51 MW WIND POWER PROJECT AT CHITRADURGA

Project Title	51 MW Wind Power Project at Chitradurga
Version	1.1
Report ID	VKU.VER.02.22_VCS_706

Report Title	51 MW Wind Power Project at Chitradurga
Client	WeAct Pty Ltd
Pages	77
Date of Issue	28-September-2023
Prepared By	VKU Certification Pvt. Ltd.
Contact	Regd. Off: Flat No. 306, Sky Star, N-1, New Rani Bagh Khandwa Road, Indore, Madhya Pradesh - 452020 URL: http://vkucertification.com e-mail: info@vkucertification.com
Approved By	Dr. Vikas Kumar Aharwal (Founder and Director) vikas.aharwal@vkucertification.com
Work Carried Out By	Abhishek Kumar Srivastava - Team Leader cum Technical Expert TA 1.2/ (Local Expert – Country: India) Niharika Kaushik - Validator/Verifier-Trainee Sanjay Kumar- Technical Reviewer cum Technical Expert TA 1.2

Figure 1.: Project implemented Location verified and mapped down WTG-wise

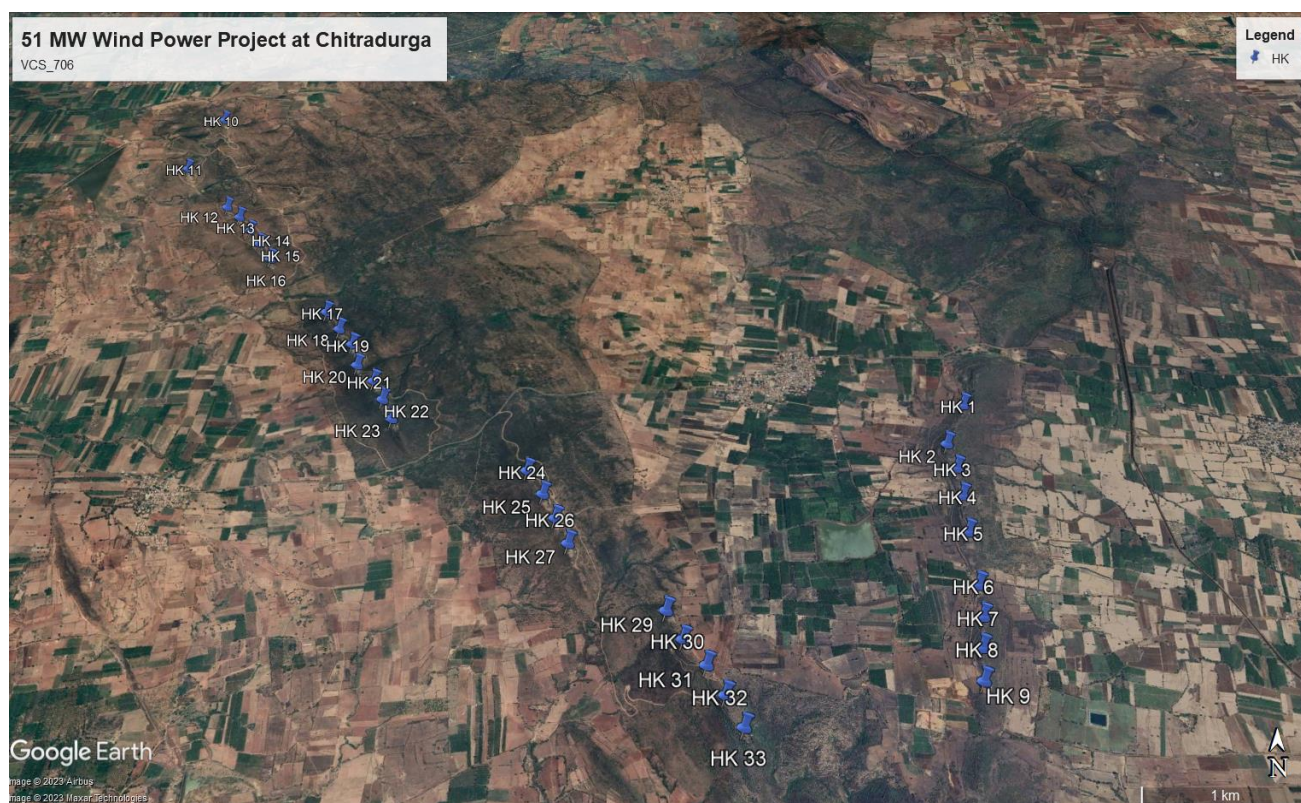
1. PP to state the status of the project activity with respect to AFLOU as per the VCS MR template in section 1.2 of MR. 2. The coordinates do not point to WTG upon checking in the google earth pro. 3. Please clarify GHG emission avoidance/removal is decreased or increased due to the project activity in SDG table in section 1.11 of MR. 4. As per VCS v4.4 para 3.18.2 this section also needs to disclose about the socio-economic impacts. OPEN. 5. Is all the energy generated from this project sent directly to the sub-station? If no, please elaborate. What is the voltage transformation that is taking place from the hub till the sub-station. The location of billing meters are not mentioned. 6. Transformer details not mentioned in the technical specifications section in 3.1 of MR 7. Since the billing is based on the meter readings taken at Hirekandavadi SS and the bulk meter reading at KN Halli SS, PP to provide the calculation involved through an illustration. Also, if the billing dates do not match with the dates of the monitoring period, how is the energy measurement performed.

1stResponse from PP	Date	28-September-2023
1. The project is not a grouped project nor an AFOLU project activity 2. The geo-coordinate has now been corrected; it only had a small change in seconds. 3. The SDG indicator number 13 is aiming to avoid the GHG emissions. 4. The section 2.2 mentions about the socio-economic impact and also in-line with registered PD. 5. Yes, all power we send directly to substation through 33kV line, Billing meters are installed in between substation and GCS towards generators. Voltage level from • Substation to WTG DP Yard: 33kV/1800KV. • WTG DP Yard to WTG Input ACB : 1800/690V • WTG Input ACB to Converter panel: 690V/420V • Converter Panel to Hub: 420V/420V 6. Technical Specification of installed ReGen Turbine DP yard transformer: 1800KVA/690V 7. Technical Specification of installed Suzlon Turbine DP yard transformer: 2500KVA/620V 8. Normally we commissioned bulk meters towards 66kV metering, then we commissioned
